**THERMALDYNE, LLC
PORT ALLEN PLANT**

**FEEDSTOCK VARIANCE REQUEST
RESPONSE TO NOD # 1**

February 2018
CK Project No. 15648

Re: Response to Notice of Deficiency (NOD) #1 for Site-Specific Variance from the
Classification as a Solid Waste Pursuant to LAC 33:V.105.O.1.c and 105.O.2.c.
Thermaladyne, LLC
✓ Agency Interest No.: 198467/PER20170004/EPA ID: TBD

Drawing: **ENLARGED SITE PLAN**

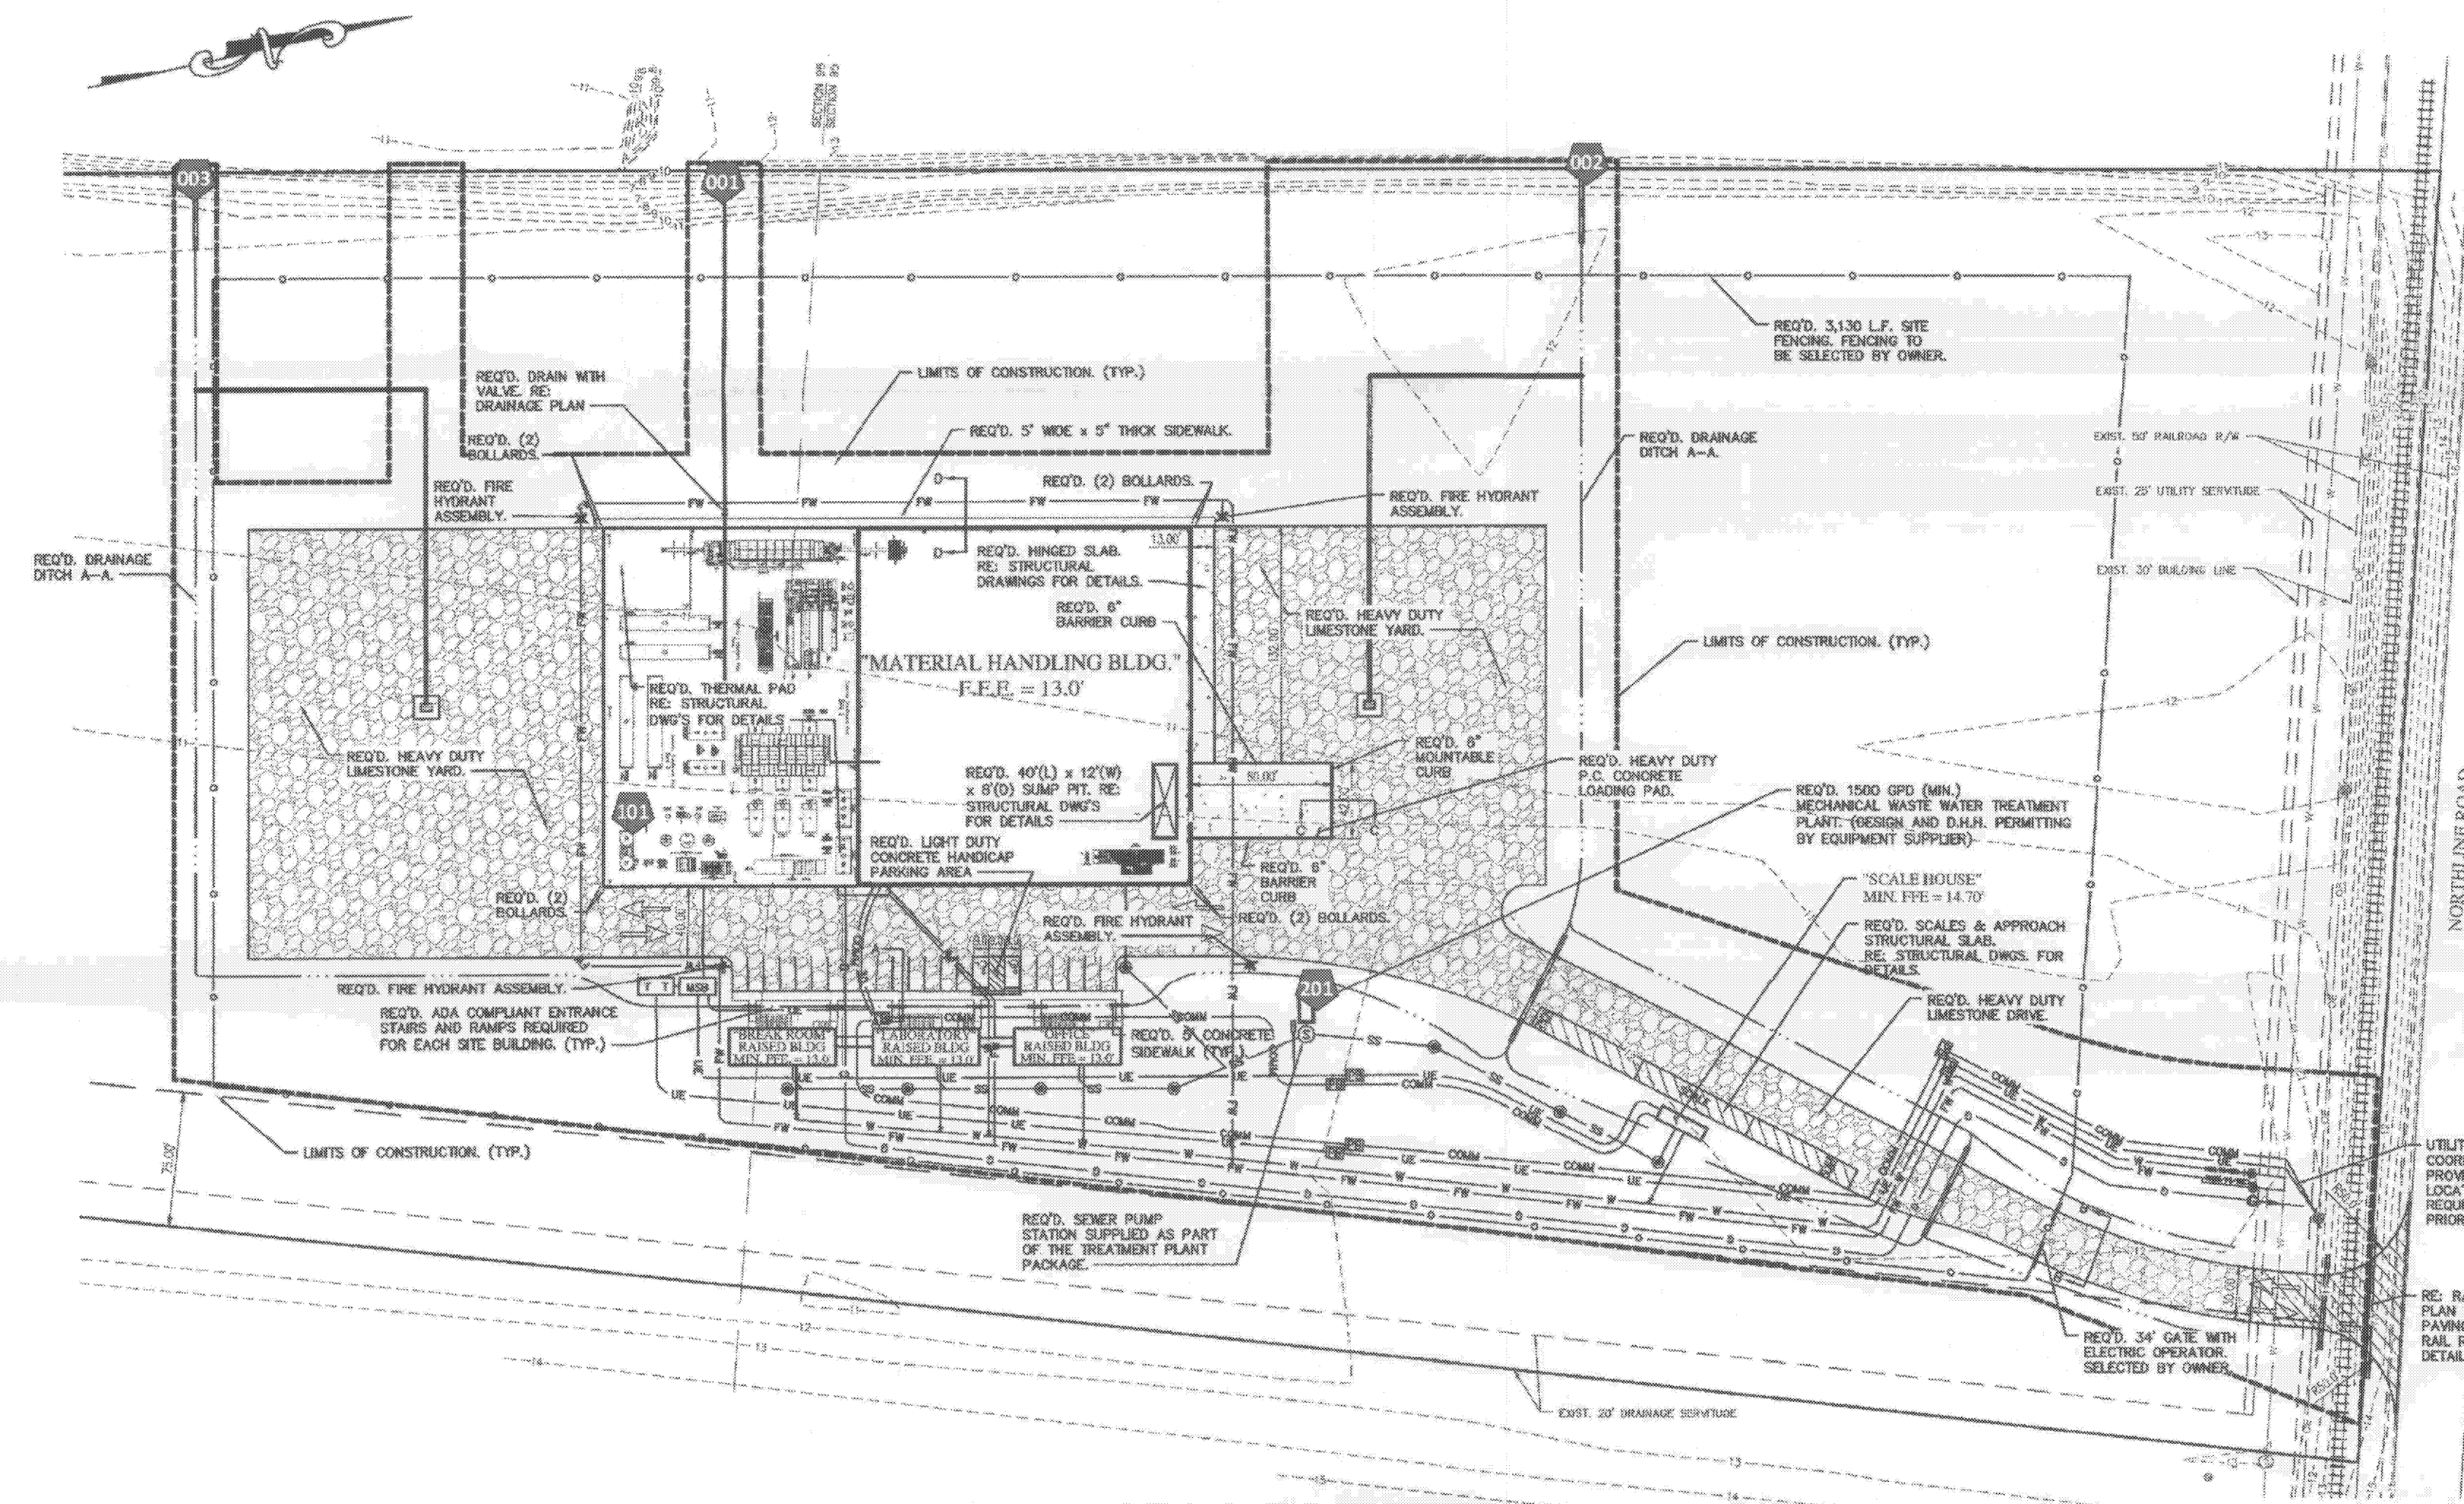
Figure C 1.2 Submit the Figure C 1.2 version of the "Enlarged Site Plan" as part of the feedstock variance request under LAC 33:V.105.O.2.b

Figure C 1.2 is provided in Appendix D of this document.

SITE PLAN AND EVACUATION ROUTES

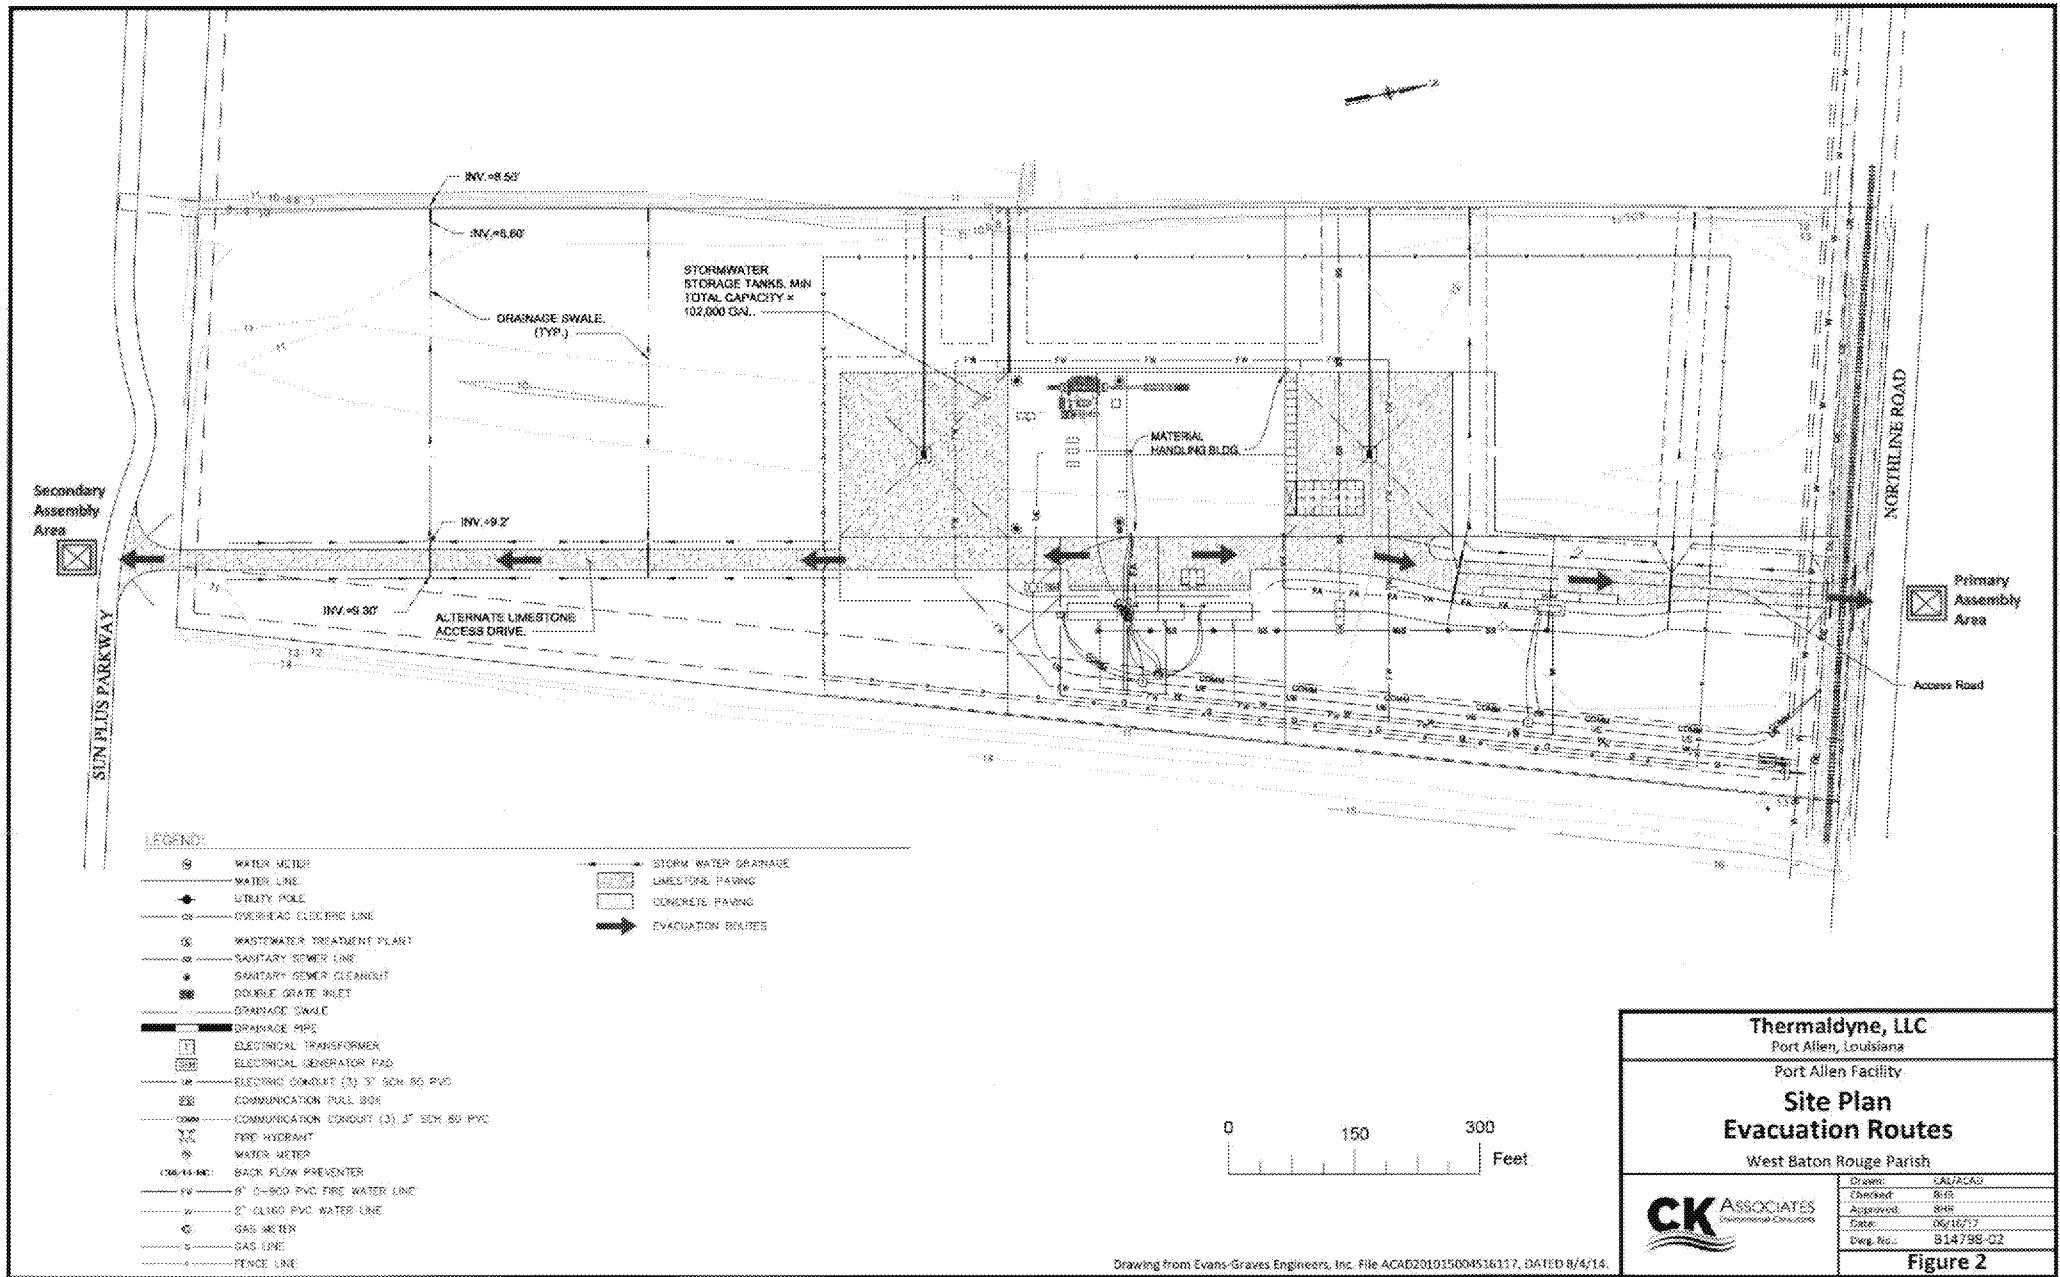
Section 6.3 Under the discussion of Evacuation Procedures the same language is used for re-entry and sheltering-in-place. Sheltering-in-place is not a form of evacuation but an action response to an incident at the facility. Should an evacuation be required after an initial action of sheltering-in-place, then alternate language needs to be discussed in this section.

Section 6.3 of the Contingency Plan has been revised to clarify procedures for sheltering-in-place.

Drawing: **LIFE SAFETY PLAN**

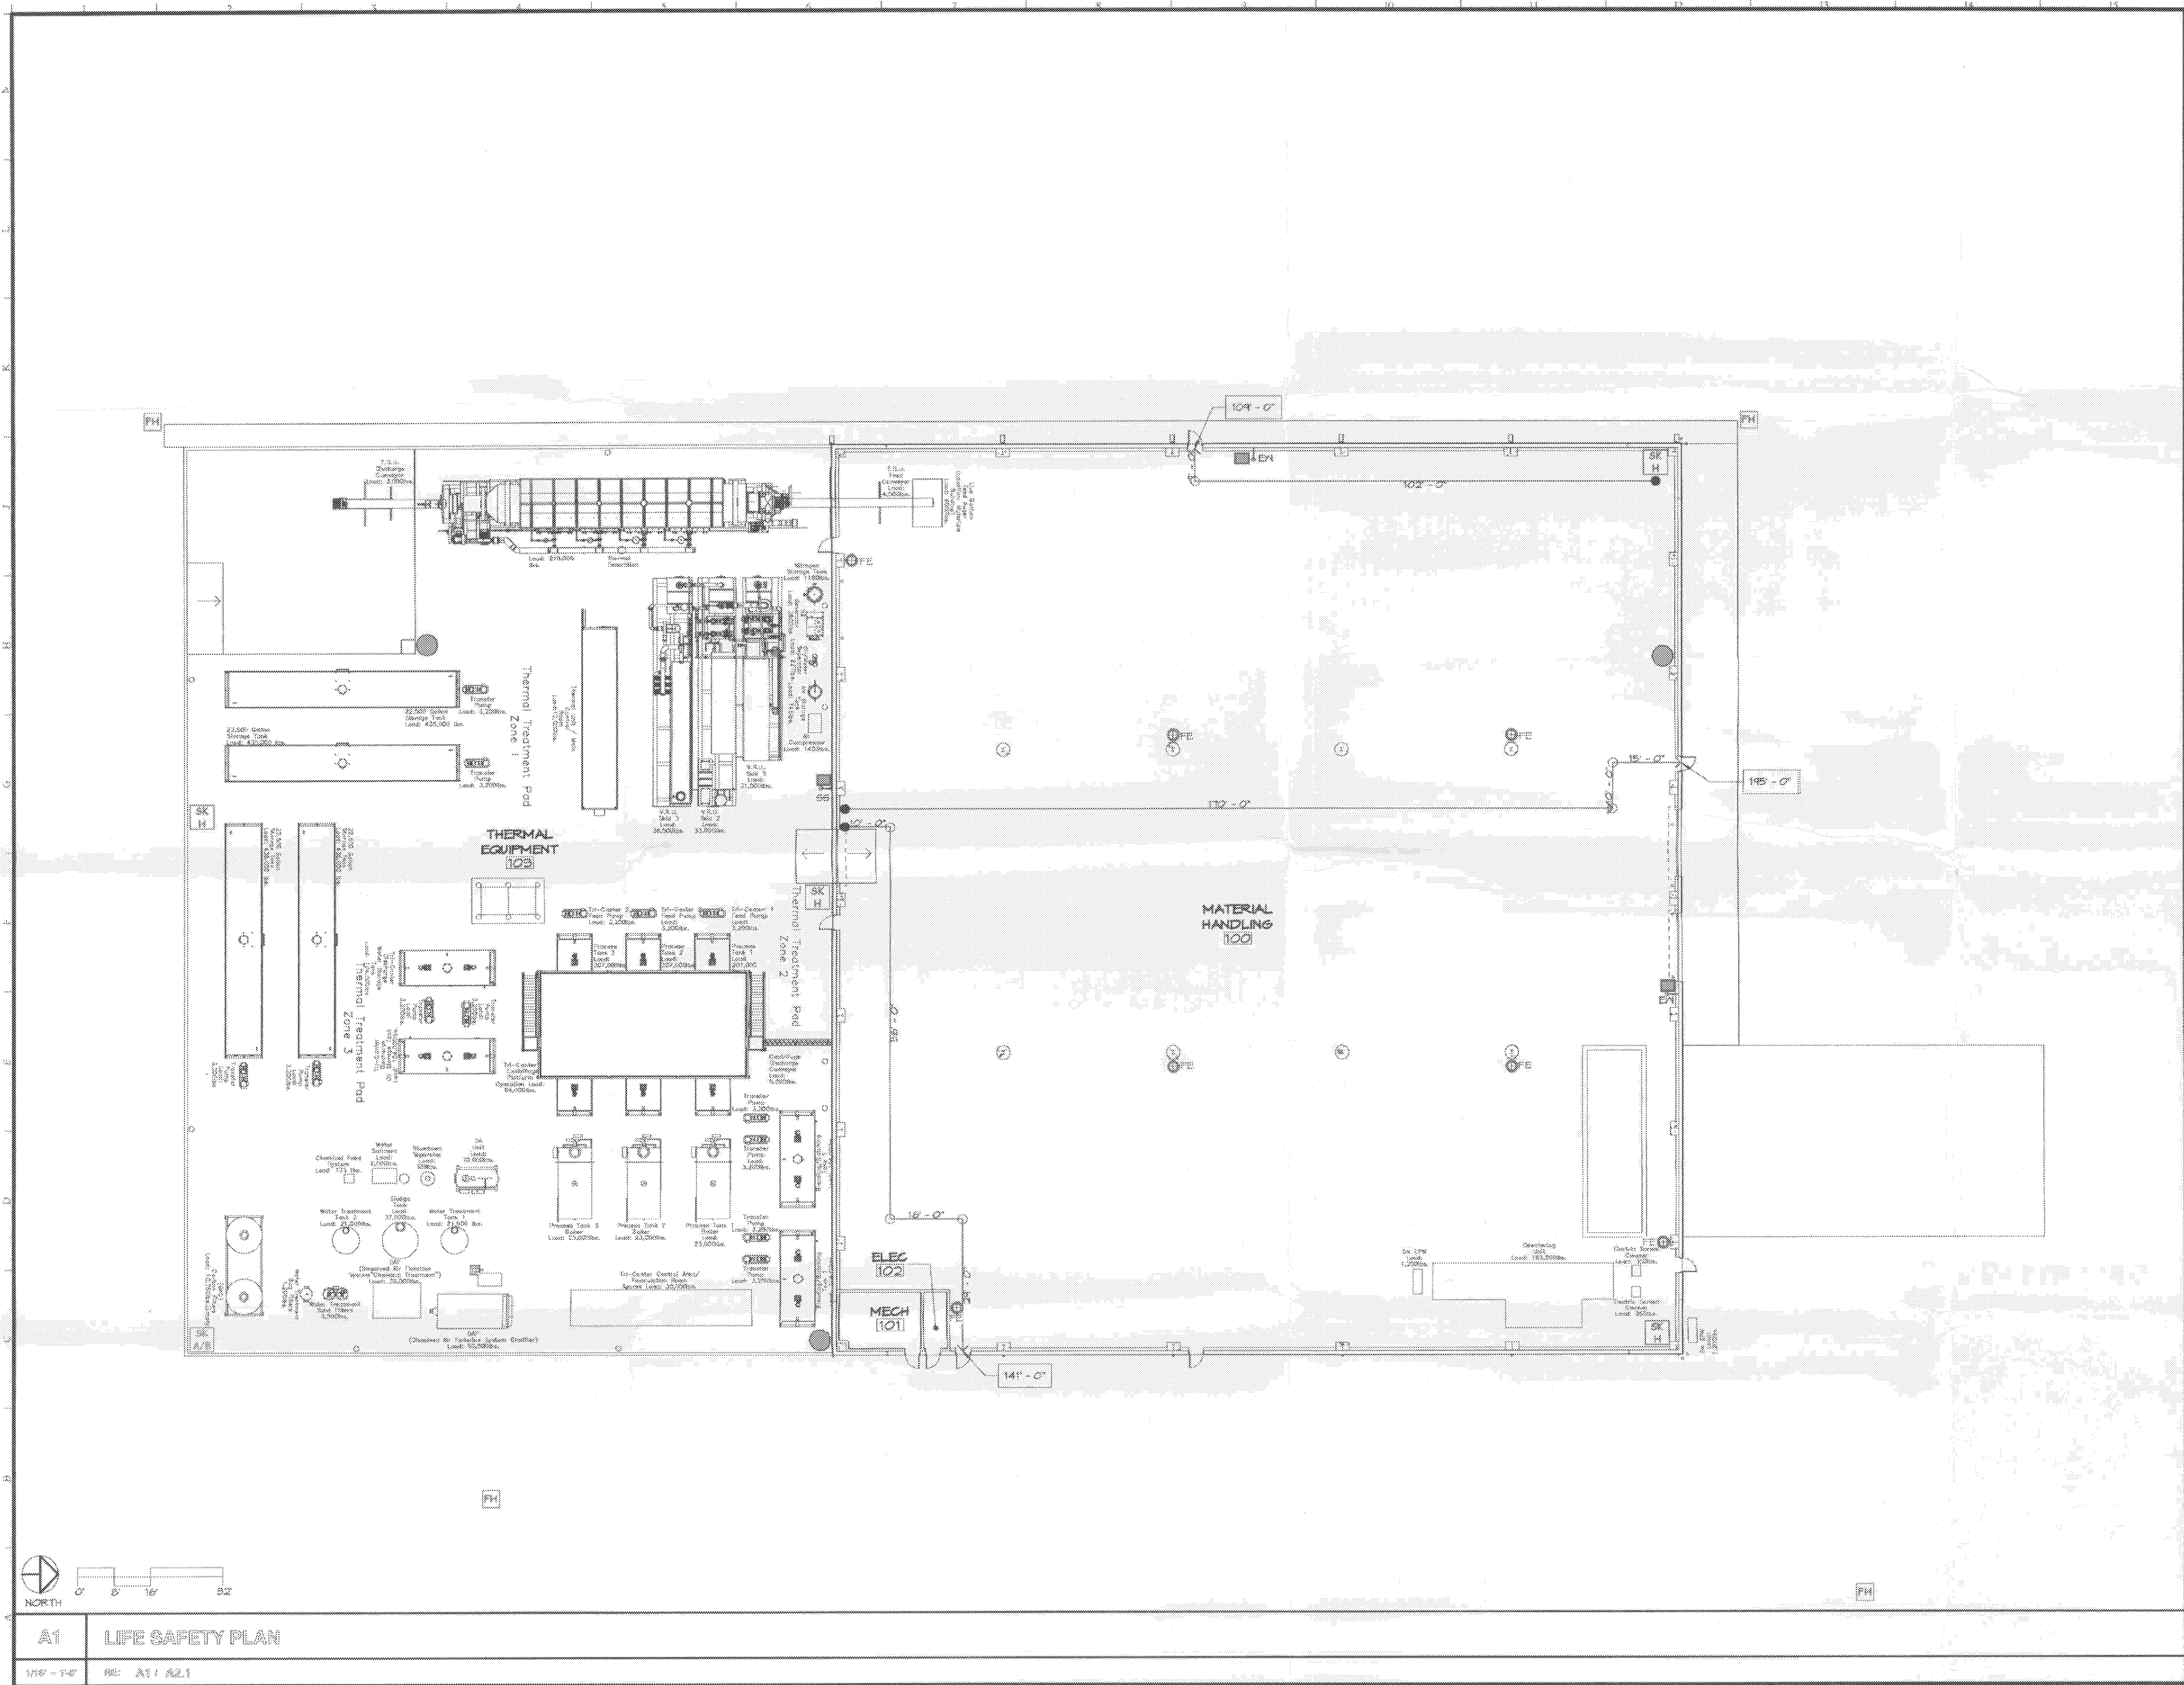
Section 3.0 A list and description of the emergency equipment was not submitted in Attachment 2 of the Contingency Plan.

Attachment 2 of the Contingency Plan has been revised to provide a list and description of the emergency equipment.
